## RESPONSE TO REQUEST FOR ADDITIONAL INFORMATION

### APR1400 Design Certification

**RAI No.:** 160-8174

**SRP Section:** 09.03.04 – Chemical and Volume Control System (PWR) (Including Boron Recovery System)

Figure 2.4.6-1 Chemical and Volume Control System

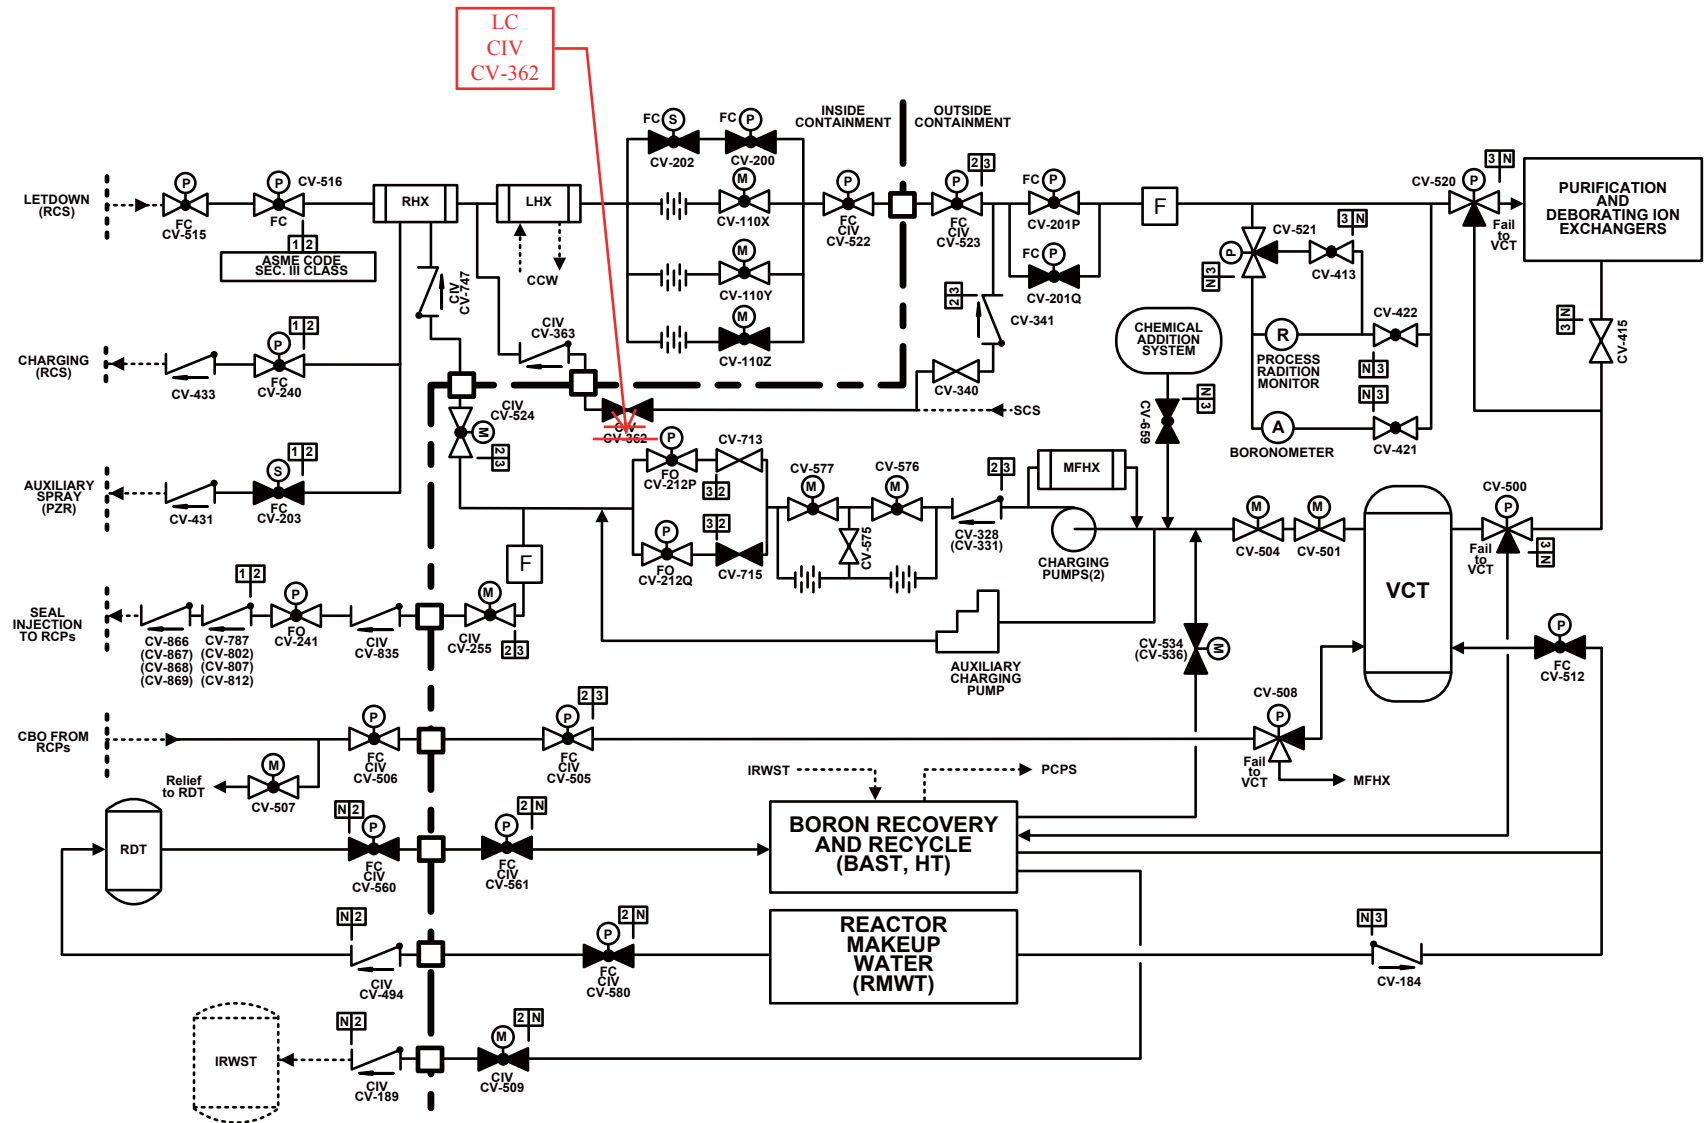
In DCD Tier 1, Figure 2.4.6-1, the staff noted that containment isolation valve, CV-362, was lacking indication of valve position status. However, in DCD Tier 2, Figure 9.3.4-1, the staff noted that CV-362 is locked closed during normal operation. Tier 1 information should be derived from and consistent with Tier 2 information.

The staff requests the applicant to update DCD Tier 1, Figure 2.4.6-1 to include valve position status of CV-362 consistent with what is shown in DCD Tier 2, Figure 9.3.4-1.

As shown in DCD Tier 2, Figure 9.3.4-1, CV-362 is locked closed during normal operation. DCD Tier 1, Figure 2.4.6-1 will be revised to make consistent with DCD Tier 2 information.

DCD Tier 1 Figure 2.4.6-1 will be revised as presented in Attachment.
